Complaint - Fuse Box in Driver's Footwell Cannot Be Opened: Folding Over Floor Covering (112/20)

Model Line: **Cayenne (9YA/9YB)**

Model Year: **As of 2020**

Subject: **Front floor covering**

Floor covering in footwell on driver's side

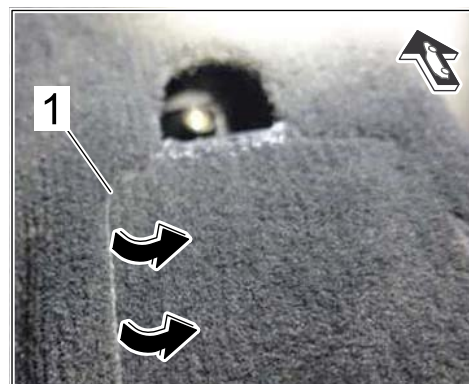
The floor covering in the footwell on the driver's side is installed without a cut-out for the fuse box since week 28/20. To access the fuse box, proceed as follows:

- 1 Remove cover on footrest fastening screw using a flat screwdriver.
- 2 Unscrew upper part of footrest using a Torx screwdriver, fold it towards the seats and remove it.
- 3 **Lift up floor covering along the perforation ⇒ Floor covering in footwell on driver's side -1-, detach it and fold it over to the right ⇒ Floor covering in footwell on driver's side -Arrows-.**
